Re: Hope Village, 1215 Third St. NW
Request for Certificate of Occupancy
Transportation Development Final Inspection
Architect's Stamp dated 5-11-20 (J14-D194)
Certification dated 01-04-22

Re: **Permanent Certificate of Occupancy for
Hope Works | Hope Village
1215 Third Street NW
Albuquerque, NM 87102**

Attachments: Site Photographs from visit conducted on 01/03/2022
Approved TCL dated 05/11/2020 with as-built redlines dated 01/04/2022

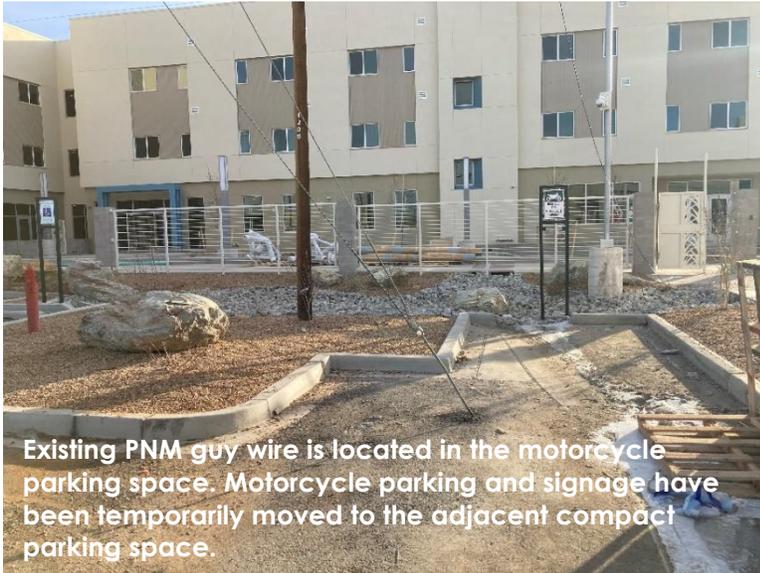
New 4th St access and compact parking spaces.
Vehicular gate to be installed later this week.

New accessible parking spaces and signage.

Existing PNM guy wire is located in the motorcycle parking space. Motorcycle parking and signage have been temporarily moved to the adjacent compact parking space.

Parking spaces next to refuse are flush with the adjacent sidewalk. Parking bumpers have been installed at 18'-0".

New parking, island, site lighting, and fire hydrant.

Relocated bike racks in central courtyard.

TITLE Traffic Circulation Layout

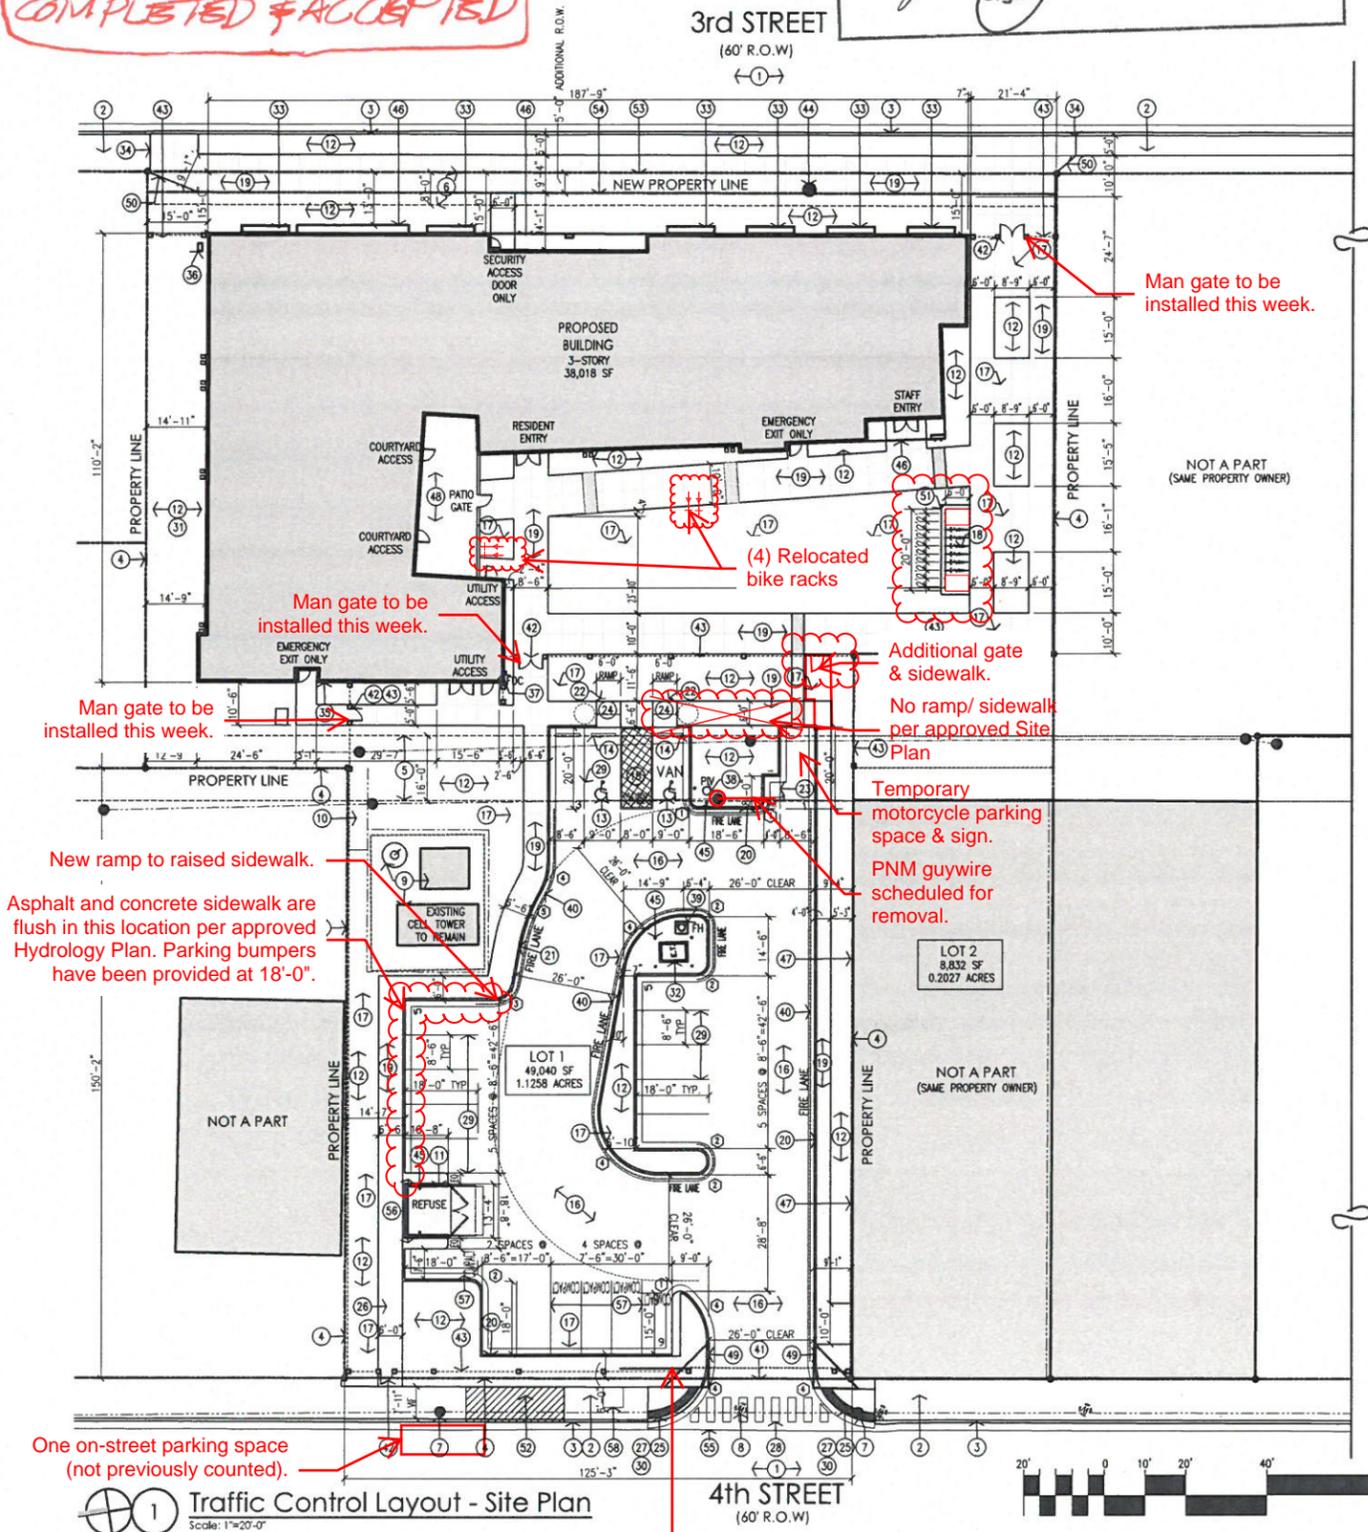
- Four of the bicycle racks were relocated from the central rack bank. Two racks were moved to the east side of the central courtyard and the remaining two were relocated to the north. The total number of bicycle parking spaces remains unchanged.

- The motorcycle parking space was temporarily moved into the adjacent Compact Parking space in order to accommodate an existing PNM guywire. PNM has been contacted to remove the wire after the Certificate of Occupancy is issued. In the interim, we are counting one on-street parking space that was not previously utilized, in order to meet the minimum parking requirement. The 'Parking Provided' calculations have been adjusted accordingly. Once the guy wire is removed, the motorcycle signage will move to the approved location and the Compact space will be marked "COMPACT" for vehicular parking.

- A portion of the sidewalk and ADA ramp to the east of the ADA parking spaces has been removed per the approved site plan. This change does not impact the accessibility route of the site.

- In accordance with the approved Hydrology and Grading Plan, parking along the north end of the parking lot is flush with the adjacent sidewalk. Parking bumpers have replaced the 6" curb shown on the Traffic Circulation Layout. A ramp has been provided to the raised portion of the sidewalk to maintain accessibility.

- The vehicular access gate along 4th Street has not been installed at this time, but is scheduled to be installed later this week.
- Site fencing is approximately 75% complete and three of the pedestrian gates will be installed alter this week. The completion of these gates does not affect vehicular circulation.
